Maps of OMA, TDP and mean power

Piers Dawe
Mellanox Technologies

Map of OMA vs. TDP

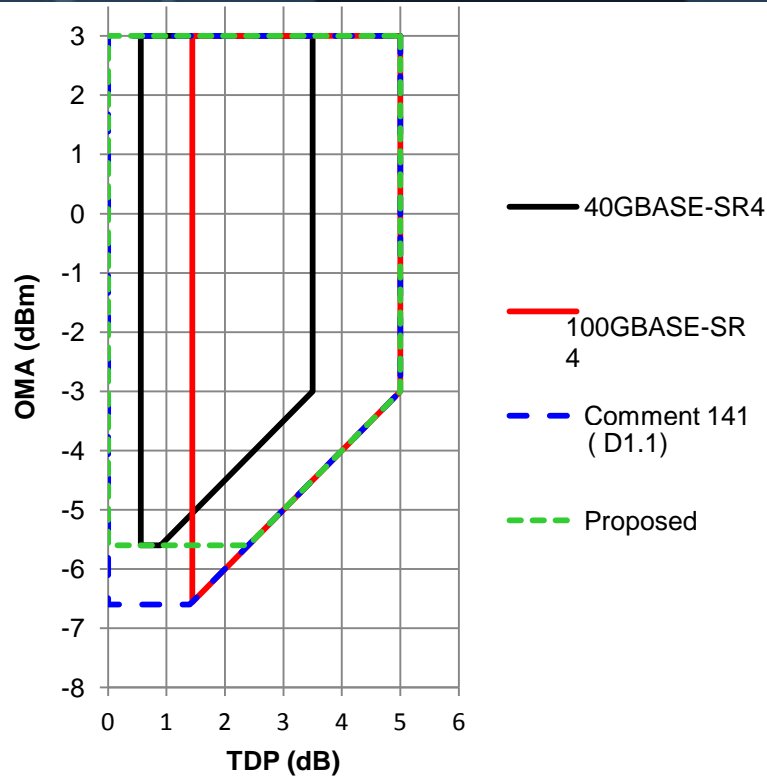
- Allowed Tx TDP and OMA in 40GBASE-SR4 and, for 100GBASE-SR4, in P802.3bm D2.0
- Transmitter is not given credit for $TDP < 0.9$ dB

- A noiseless Tx with 1 ps risetime would have TDP of 0.44 dB for 40GBASE-SR4 and 0.76 dB for 100GBASE-SR4 (from spreadsheet model: ISI at decision timing offsets)
- For 12 ps, this becomes 0.56 dB or 1.44 dB (illustrated)
- TDP is not likely to be below 1.5 dB
- Cutoff line for TDP credit needs revision

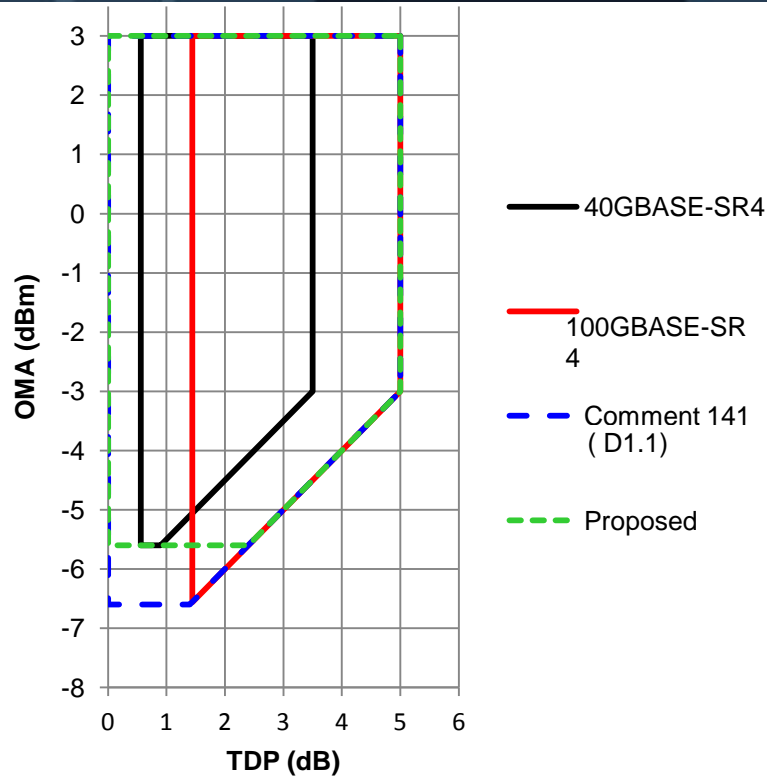
- We should raise the minimum OMA for low-TDP Tx until there is a moderate flat region at the bottom
- We might as well use the same limit as 40GBASE-SR4: -5.6 dBm
 - This makes operation and diagnostics of a mixed 40GBASE-SR4 / 100GBASE-SR4 network a little easier
 - No cost foreseen because this still offers an 8.4 dB tall setup window for any future low-TDP transmitter

- Table 95–6, 100GBASE-SR4 transmit characteristics, note b:
 - Even if the TDP < 0.9 dB, the OMA (min) must exceed this value.
- Instead of 0.9 dB, use 2.4 dB
- The minimum average power on each lane would also be increased
 - See next slide

Choosing minimum average input power at receiver

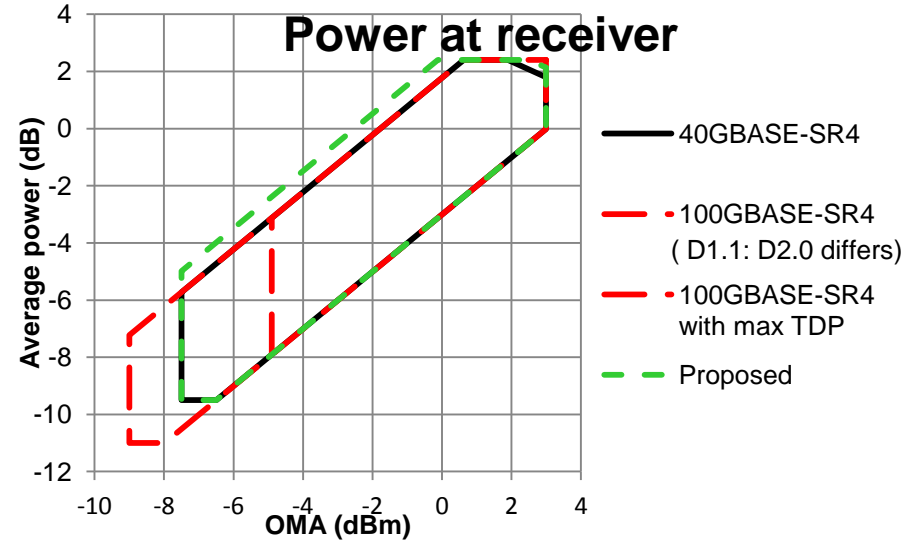
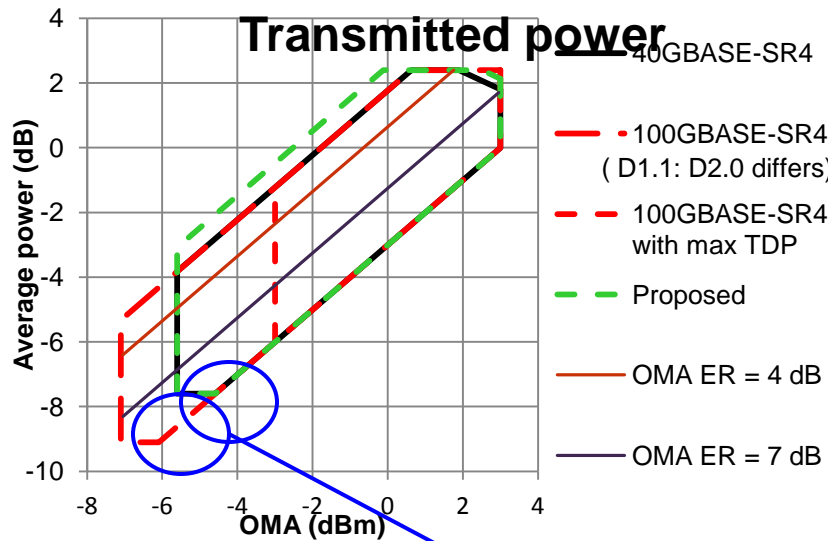
Minimum extinction ratio in D2.0 is lower than shown: this affects upper diagonal lines only

A directly modulated VCSEL is unlikely to have very high extinction ratio AND very low TDP

Power at receiver is 0 to 1.9 dB less than launch power

- Slide 4 shows that -5.6 dBm is a suitable Tx OMA minimum
- The draft -9.1 dBm minimum average launch power is unlikely to happen: it would need very high extinction ratio together with very low TDP
- -7.6 dBm, as in 40GBASE-SR4, looks suitable
- The minimum average input power at the receiver (TP3) would become -9.5 instead of -11 dBm
- Note: these maps assume that all ones and zeros are the same
 - No distinction between "OMA extinction ratio" and "SONET extinction ratio"
 - Peak power calculated as average power in ones – true peak can be higher because of overshoot
